November 7, 1984

The Commission has issued the enclosed Amendment No. 87 to Facility Operating License No. DPR-23 for the H. B. Robinson Steam Electric Plant Unit No. 2. This amendment consists of changes to the Technical Specifications in response to your request dated July 23 and August 1, 1984, as supplemented by letters dated August 8, 17, 20(2), and 23, 1984; September 7(2) and 17, 1984; and October 4, 12, and 22, 1984.

SAFETY EVALUATION BY THE OFFICE OF NUCLEAR REACTOR REGULATION  
RELATED TO AMENDMENT NO. 87 TO FACILITY OPERATING LICENSE NO. DPR-23  
CAROLINA POWER AND LIGHT COMPANY  
H. B. ROBINSON STEAM ELECTRIC PLANT, UNIT NO. 2  
DOCKET NO. 50-261

FIGURE A-14

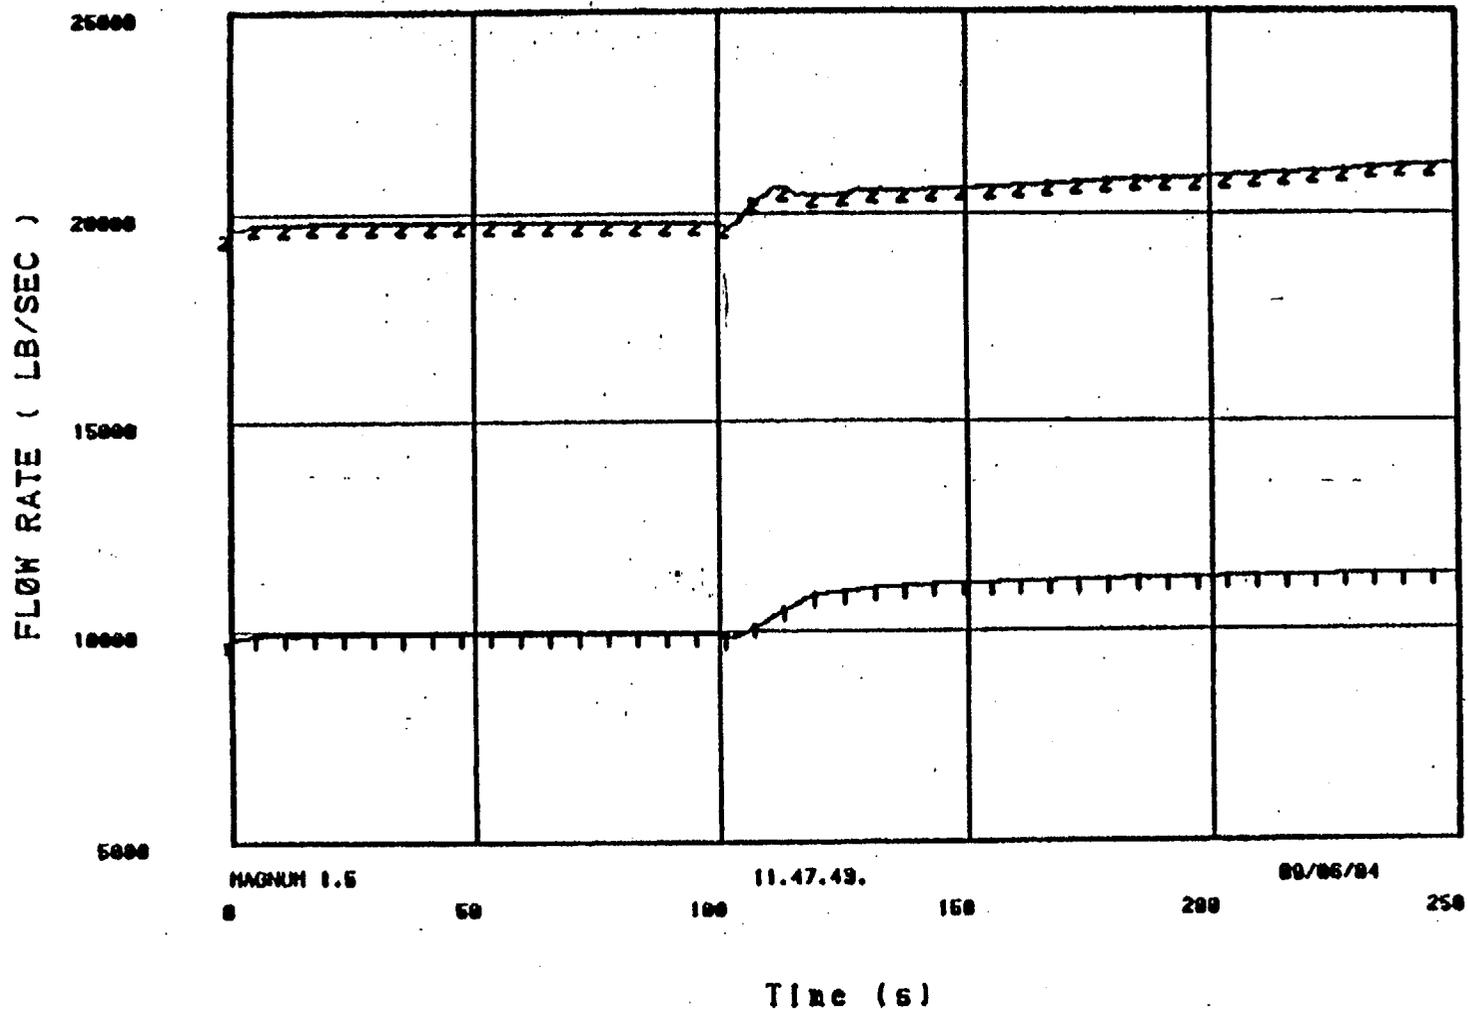
the energy generated by the core. The addition of borated ECC water assures a steady decline in reactor power. As the primary system coolant temperature is decreased, the primary system flow increases. This is in response to the increasing density. Figure A-14 shows that primary system flow as a function of time.

FIGURE A-15

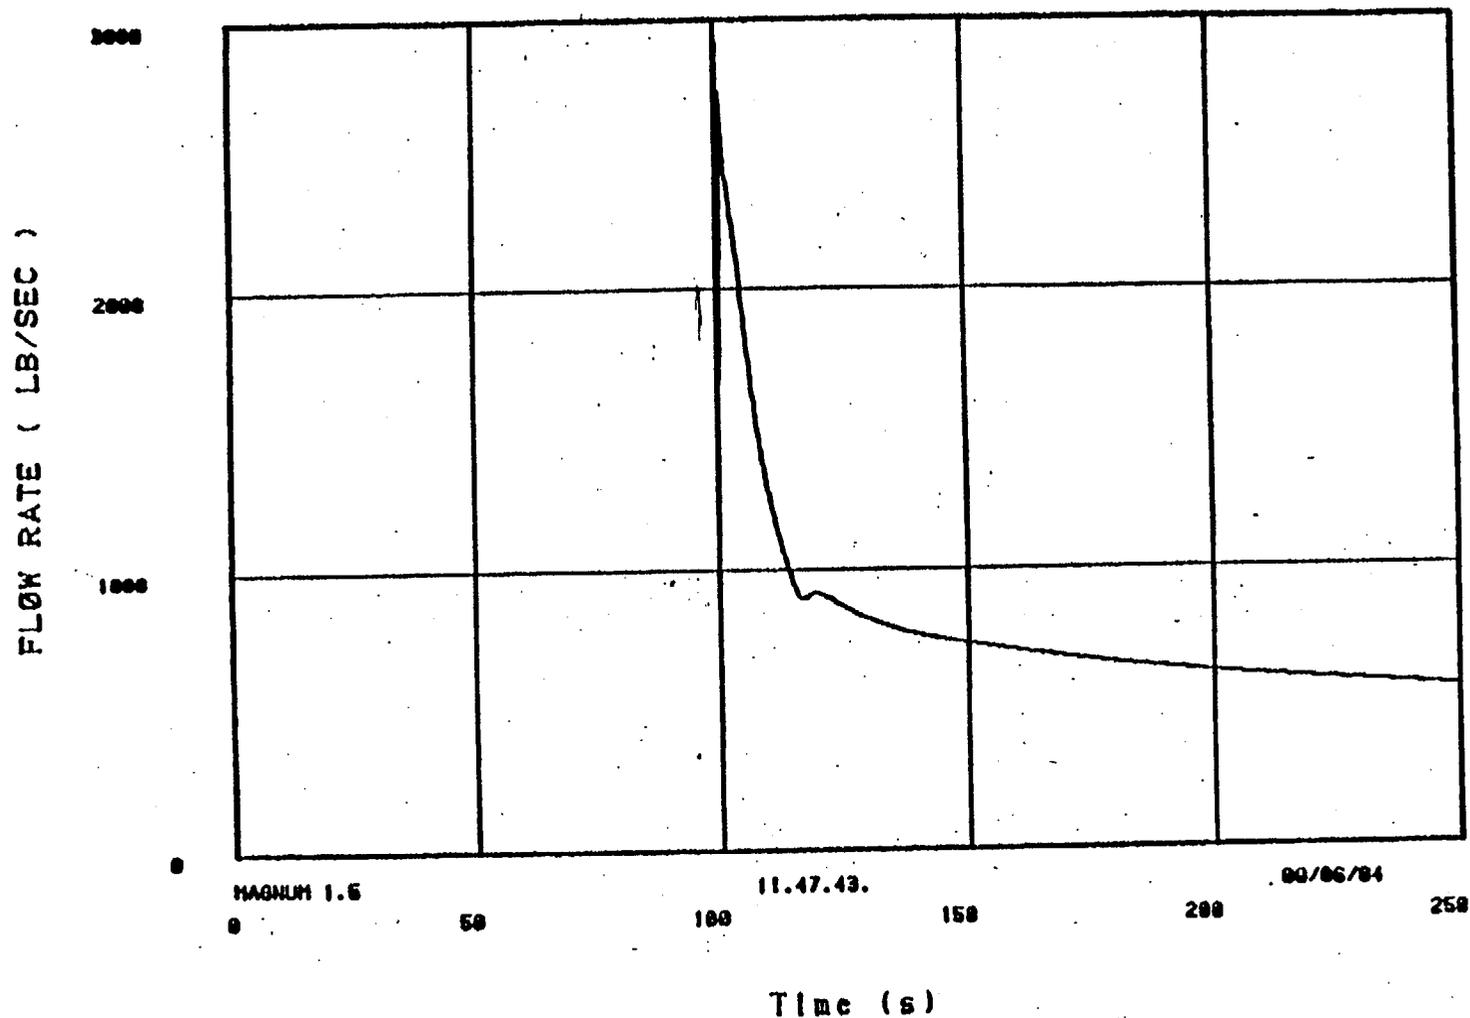
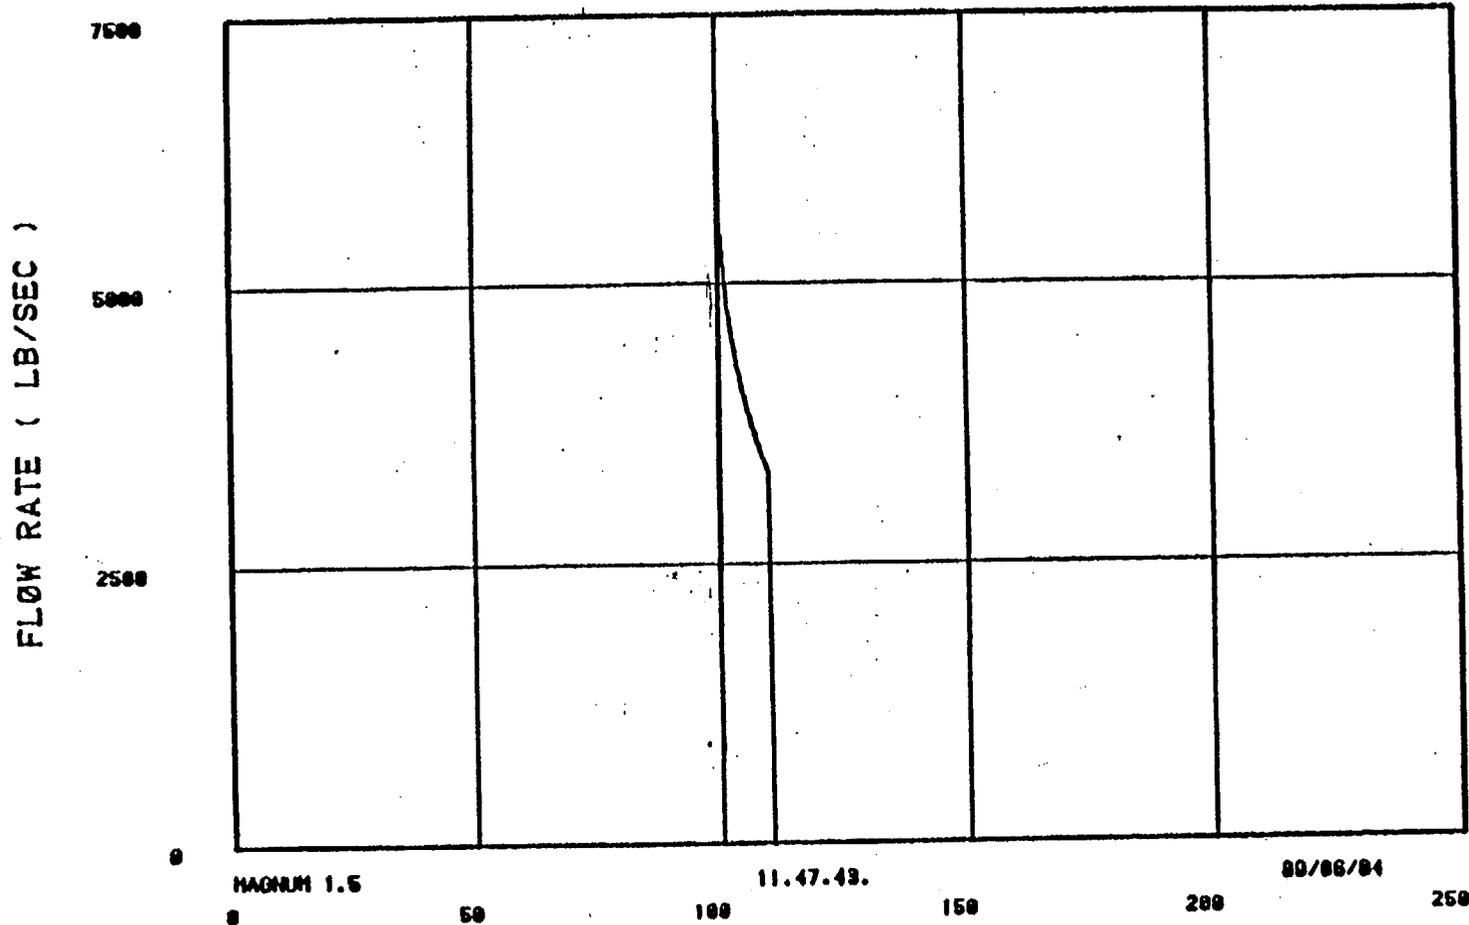
Figure A-15 and A-16 describe the break flow characteristics for the affected and intact steam generators, respectively. The blowdown of the steam generators is the primary forcing function for the SLB transient. At 150 seconds into the event (250 seconds of plot time), the break flow from the affected steam generator decreased to 577 lbm/sec. This is equivalent to the 20% of rated steam flow. The rapid isolation of the intact steam generators result from closure of the MSIVs.
